September 19, 1996

RE: Additional Information Requested for Amendment to Registration for
Registry #NR-122-D-101-S

This letter is in response to your letter dated August 12, 1996, regarding registration of the Model MK 1.0 transmission gauge. We have evaluated your response. However, in order to continue our review, the following information is necessary:

REGISTRY OF RADIOACTIVE SEALED SOURCES AND DEVICES
SAFETY EVALUATION OF DEVICE
(Amended page 1 - September 16, 1996)

700-5652/3

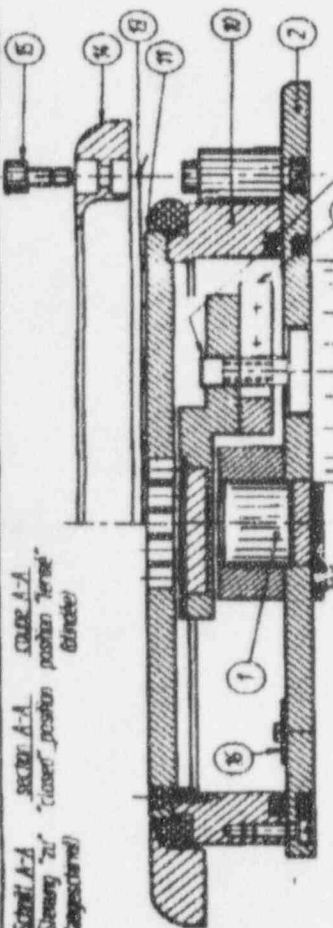
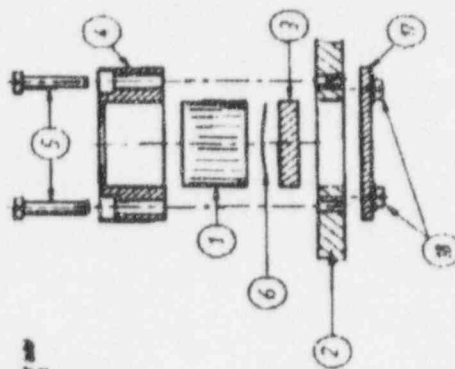
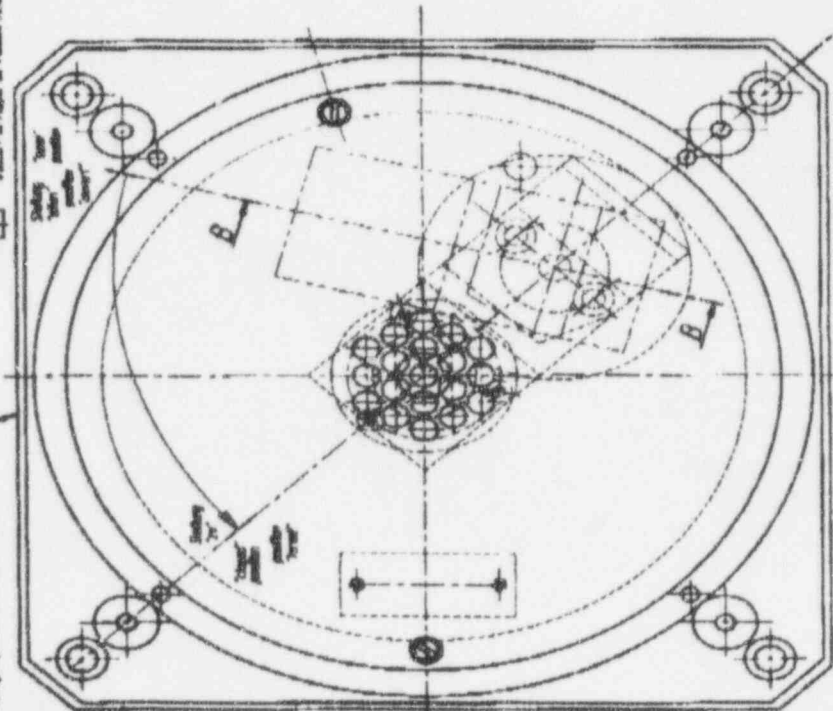
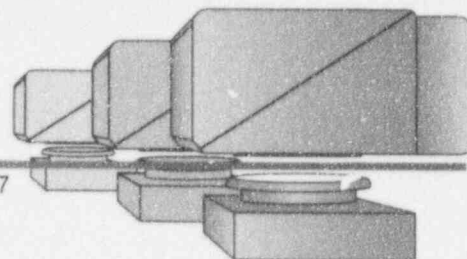
6. The text listing the part descriptions on the drawing submitted in your letter is unreadable. Please resubmit a clear drawing.
7. Section 1.1 in the GL user's operations manual and section 1.1.3 in the service manual states that "... persons working at the control area must wear a radiation dosimeter. The type of radiation dosimeter to be worn is prescribed by the supervisory authority...".

6. Attachment #4 is a key to the "bubble" numbers on drawing 700-5652/3 (attachment #3). Additionally a clear drawing is supplied.
7. We verify that this paragraph will be removed from the GL operation and service manuals.

Key to "Lubbles" on drawing 700-5652/3

bubble number	description
1	radiation source
2	base plate steel 5mm
3	distance ring 3.5mm
4	cover plate steel
5	fixing screws M2.5x12
6	spring
7	turning magnet with built-in recoil spring
8	mounting base (terminal on the turning magnet axis)
9	allen screw M4x6
10	distance ring steel 11.5mm
11	collimator plate compl. brass 5mm
12	shielding bracket with 4mm lead
13	cover foil polyester 0.05mm (70 g/m ²)
14	holding ring
15	allen screw
16	label for source data
17	cover plate
18	fixing screws M2.5x6

ATTACHMENT #6

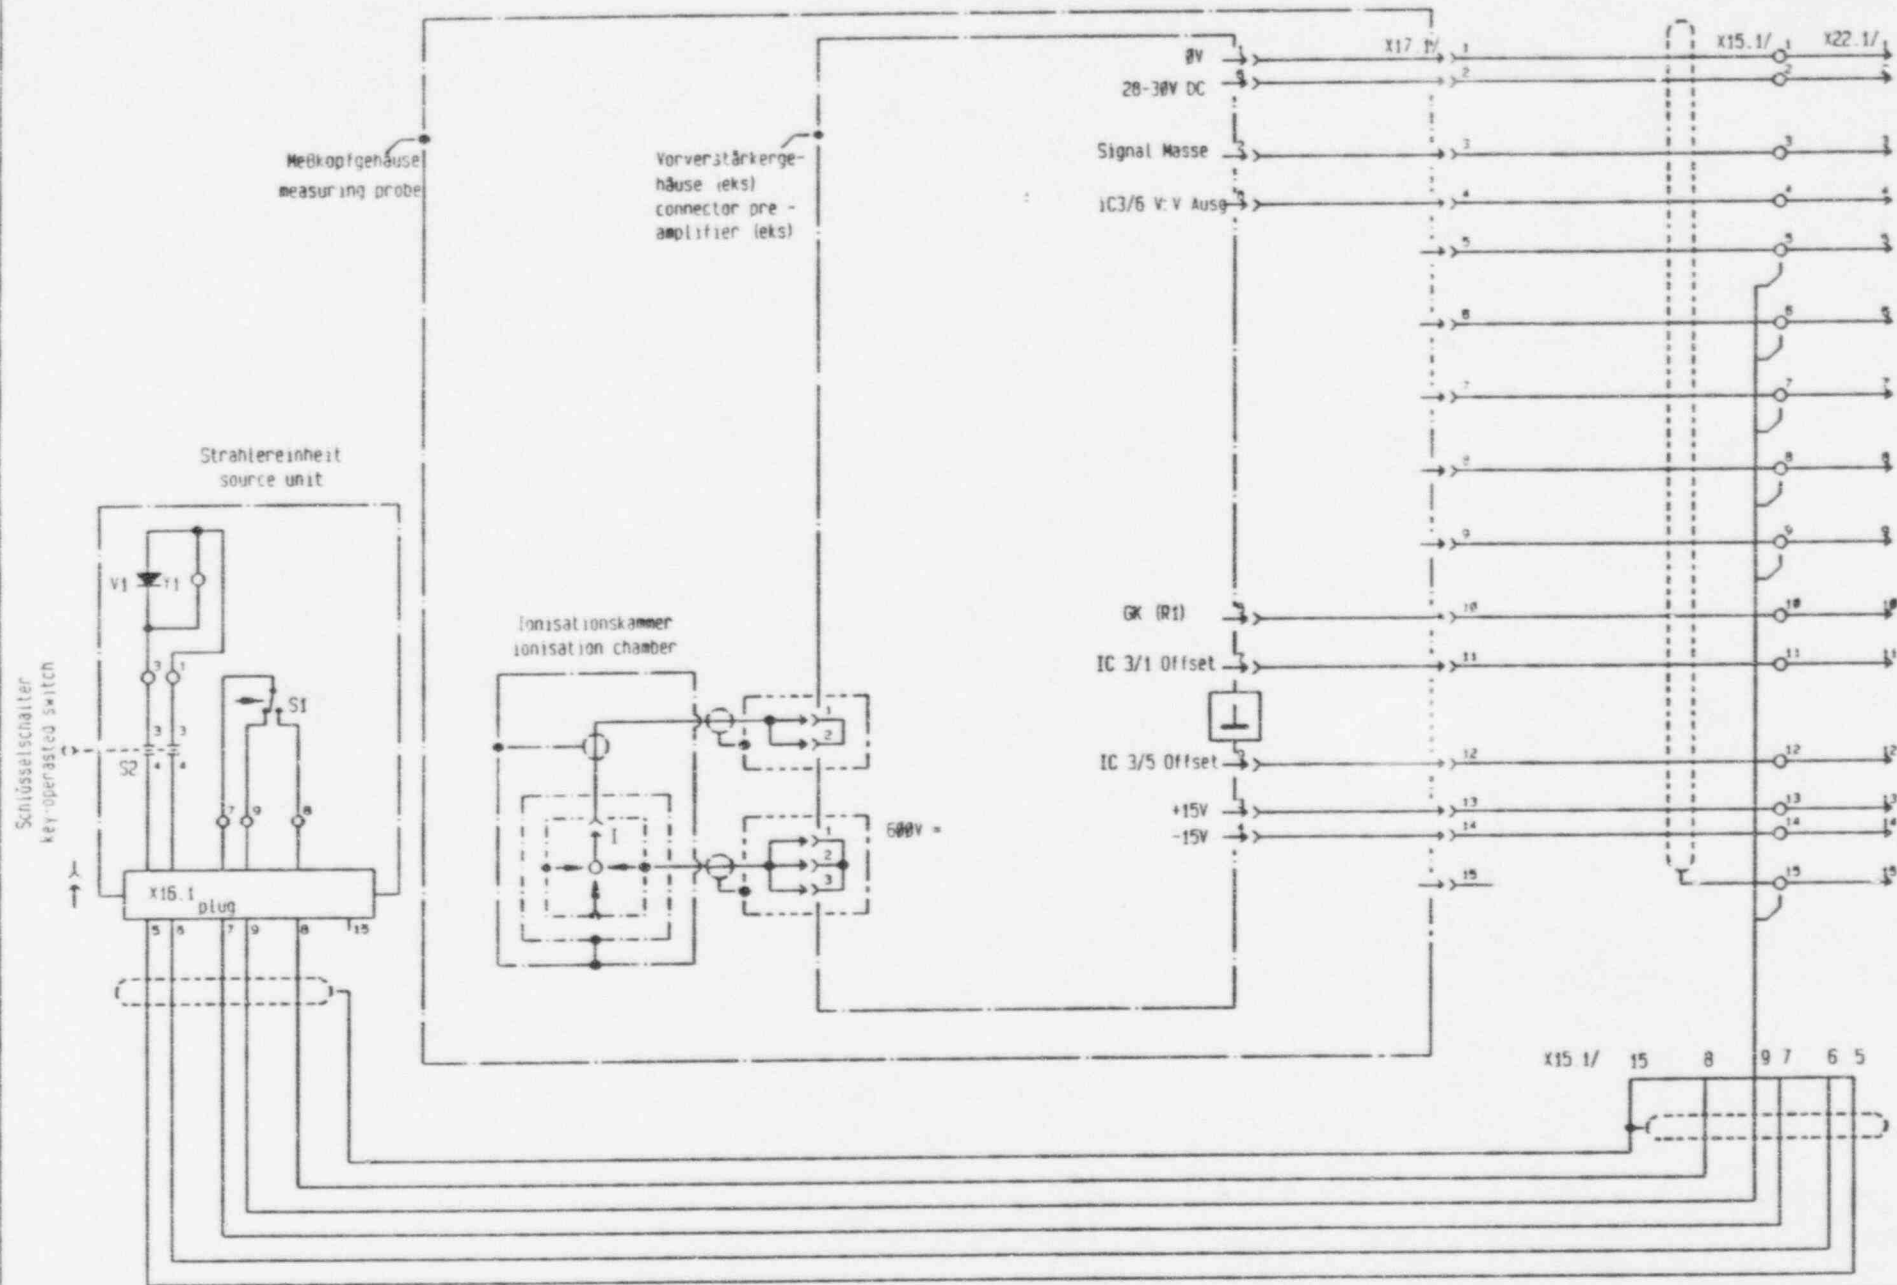
3. Please provide a description or drawing that clearly indicates the position of the "on/off" indicator lamps, and that demonstrates that they are readily visible in the mounted position.

3. Attachment #6 indicates the position of the warning panels on both sides of the scanning frame. The triangular construction allows viewing from all directions. When "C" frames or fixed point sensors are used the mounting positions of the warning panels is installation dependent. Each panel contains four (4) lamps, two (2) for the ON indication and two (2) for the OFF indication. Each pair of lamps is wired in parallel to allow a functioning lamp in the event one lamp of a pair fails.

ATTACHMENT R7

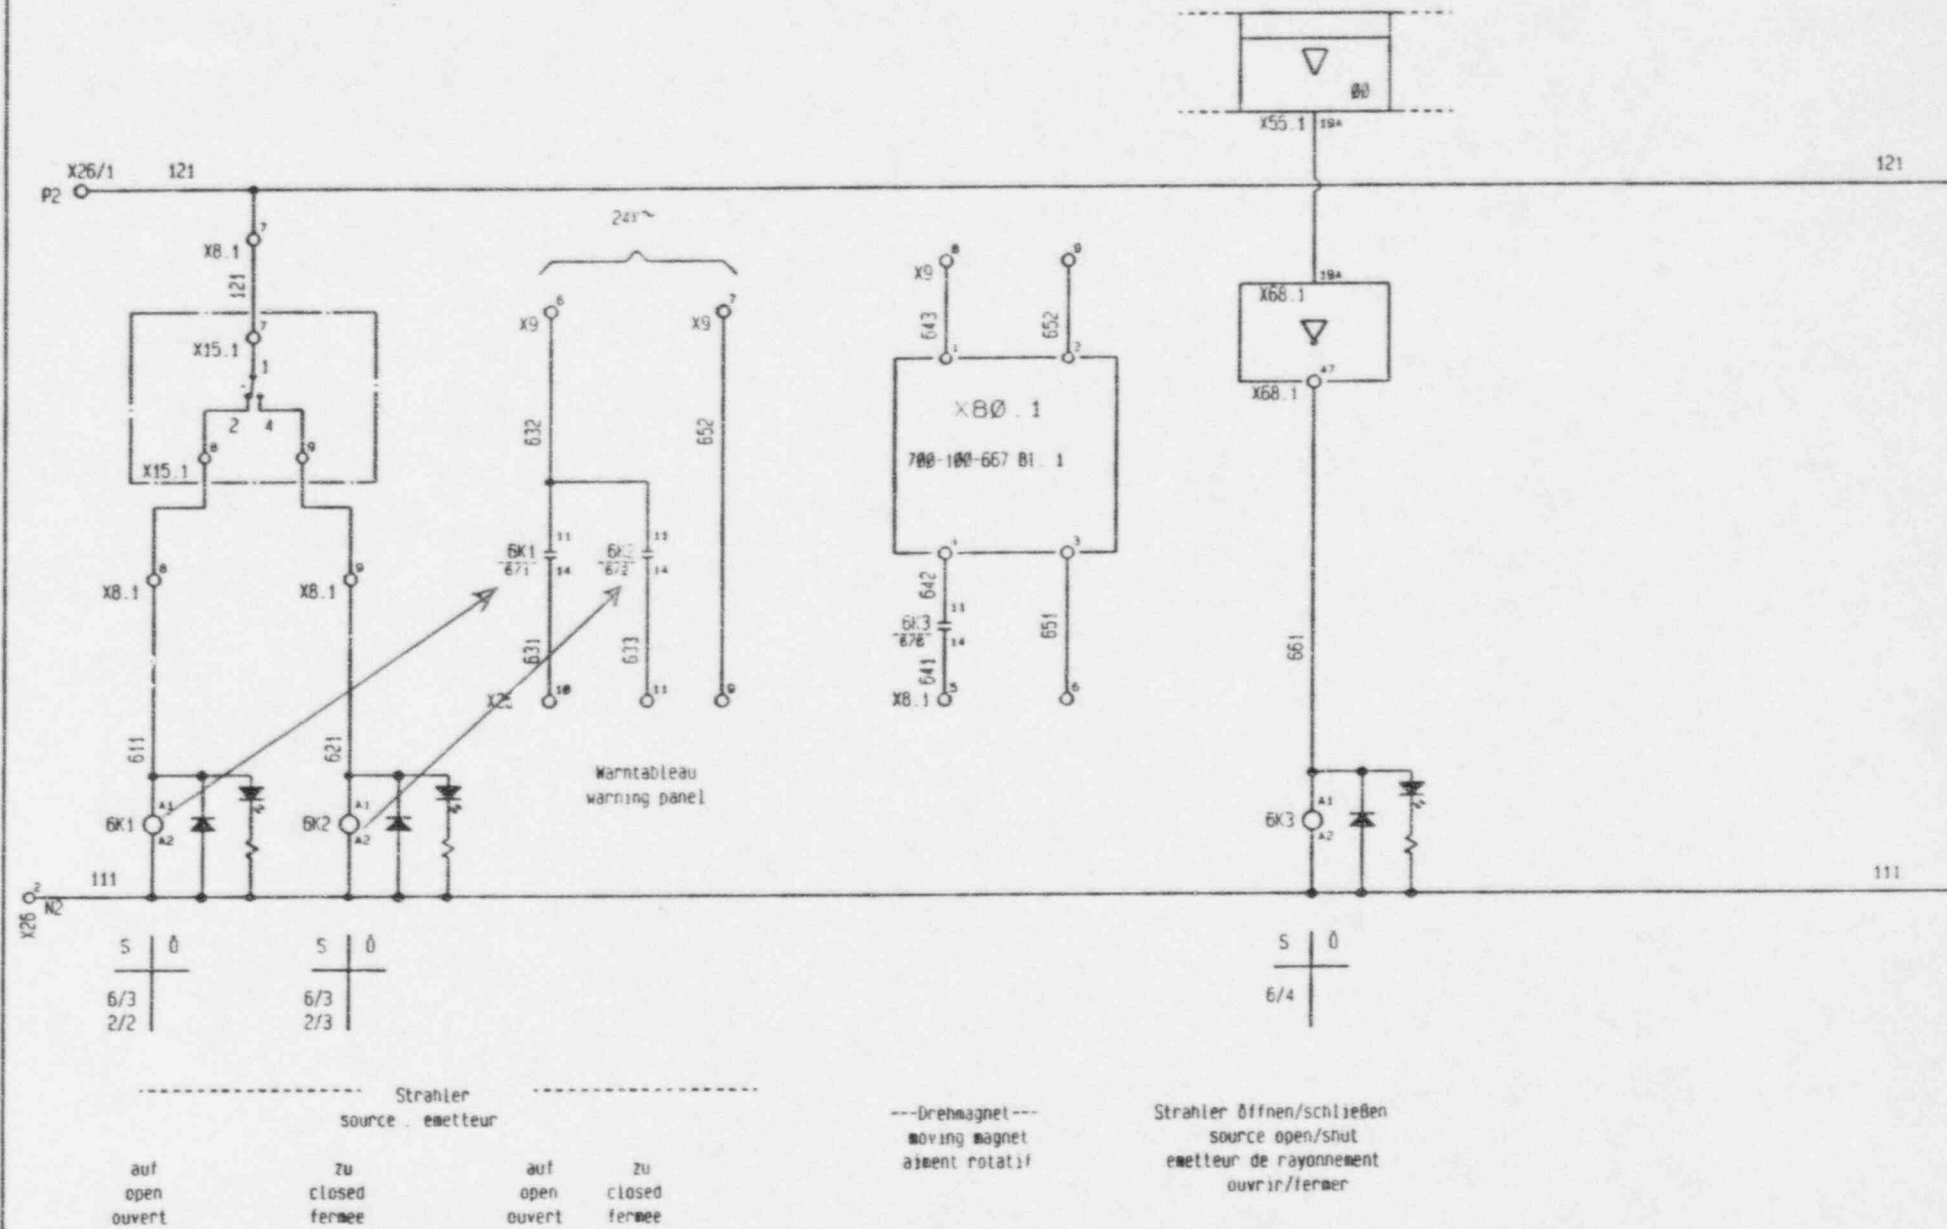
4. Please verify that the GL user will not be required to remove any tamper-resistant screws in order to perform any service.
5. Please provide complete instructions that a person using the device under a general license (GL user) will follow to perform the on/off test. The procedure listed in your letter appears to test whether the lights are in working order but it is not clearly apparent that it tests the function of the shutter itself. Please provide additional information to clarify this apparent deficiency. In addition, please explain how the on/off lights function. For example, are the lights triggered by the switch independent of the shutter movement or triggered by the shutter movement? The method used to check whether the shutter is actually functioning correctly may be checked against expected readings from the console that demonstrates that the shutter is opened or closed.

Switch S1 (attachment #7) is actuated by an arm which is physically attached to the shutter mechanism and only contacts the switch when fully closed. The shutter is closed by the absence of power to the rotary solenoid (item #7 attachment #3) and pulled to the closed position by a spring. With the shutter closed power is supplied to terminal 7 through terminal 9 to energize relay 6K2 (attachment #8). The contacts of this relay (attachment #8) close providing 24vac to terminal 11 through cable #10 (attachment #9) to terminal 11 to the warning panel OFF lamps (attachment #10). When power is applied to the rotary solenoid (item #7 attachment #3) the arm attached to the shutter moves off the switch S1 (attachment #7). This allows power from terminal #7 through terminal 8 to energize relay 6K1 (attachment #8). The contacts of this relay (attachment #8) close providing 24vac to terminal 10 to the warning panel ON lamps (attachment #10). Additional sets of contacts on relays 6K1 and 6K2 provide digital input signals to the processor which signals the keypad LED to illuminate when the shutter is open and extinguish when the shutter is closed.
